LICENSEE: System Energy Resources, Inc.
FACILITY: Grand Gulf Nuclear Station, Unit 1
SUBJECT: SUMMARY OF JUNE 14 AND 15, 1988 MEETING REGARDING
POTENTIAL CHANGES TO TECHNICAL SPECIFICATIONS

On June 14 and 15, 1988, the NRC staff met with representatives from System Energy Resources Inc., (SERI) to discuss potential changes to Technical Specifications (TS) to be submitted in 1988. Enclosure 1 is a list of participants. Enclosure 2 contains potential TS changes.

POTENTIAL CHANGES TO TECHNICAL SPECIFICATIONS

FIGURE 4.7.4-1
(SAMPLE PLAN 2) FOR SNUBBER FUNCTIONAL TEST

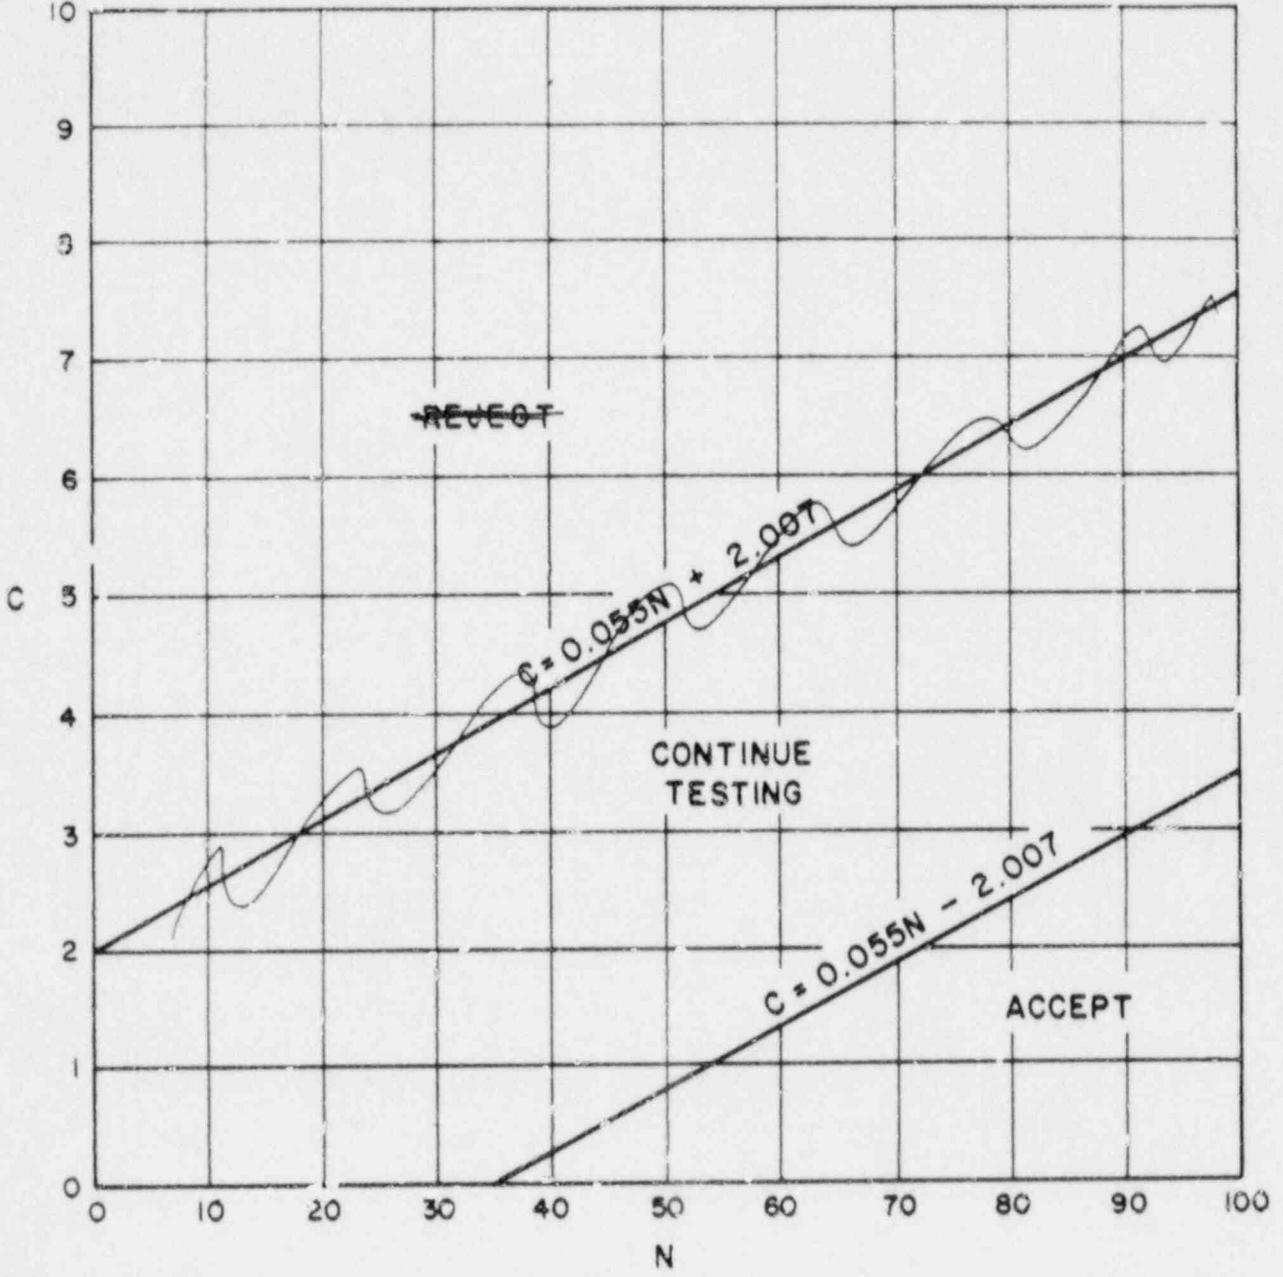
The licensee would like to delete the reject region on TS Figure 4.7.4.-1, "Sample Plan For Snubber Functional Test" (Sheet 8 of Enclosure 2). This would eliminate the need to test all snubbers for some test failures. The staff indicated this type of change has been considered previously.
